OYSTER CREEK NUCLEAR GENERATING STATION, UNIT NO. 1

AMENDMENT TO PROVISIONAL OPERATING LICENSE

Amendment No. 35
License No. DPR-16

ATTACHMENT TO LICENSE AMENDMENT NO. 35

FIGURE 3.10-1
 MAXIMUM ALLOWABLE AVERAGE PLANAR
 LINEAR HEAT GENERATION RATE

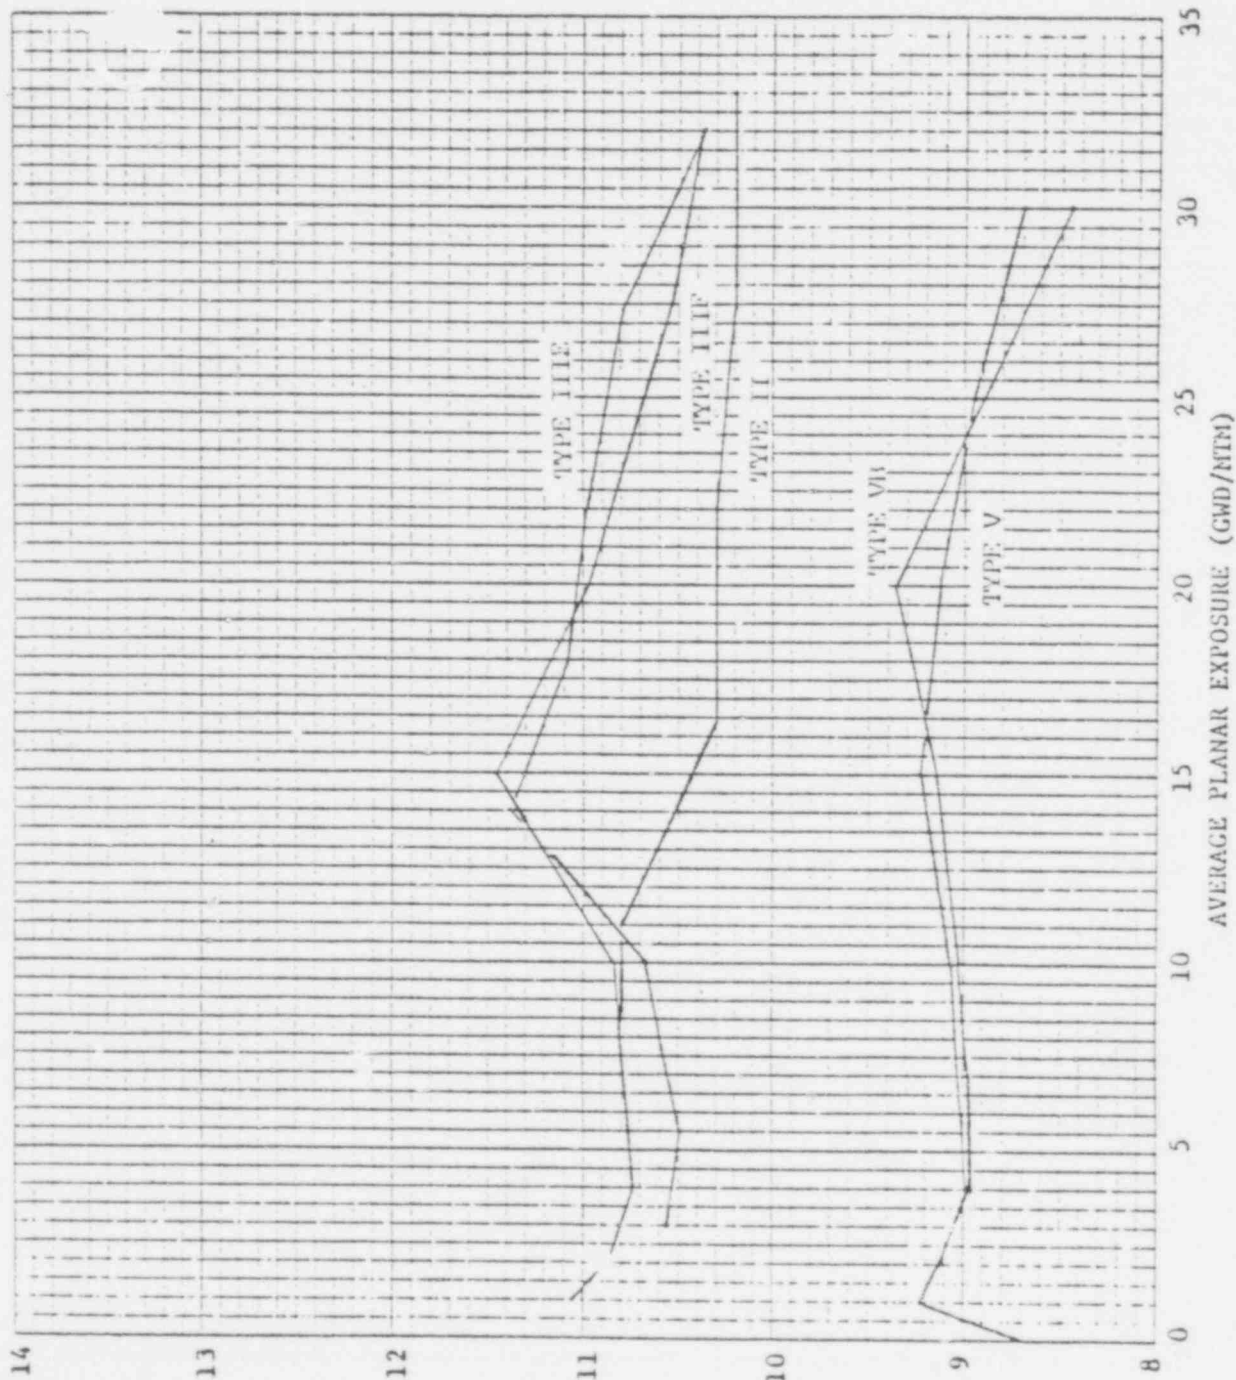
INTERIM MAPLEGR LIMITS
 FOR 4 RECIRCULATION
 PUMP OPERATION IN OYSTER CREEK
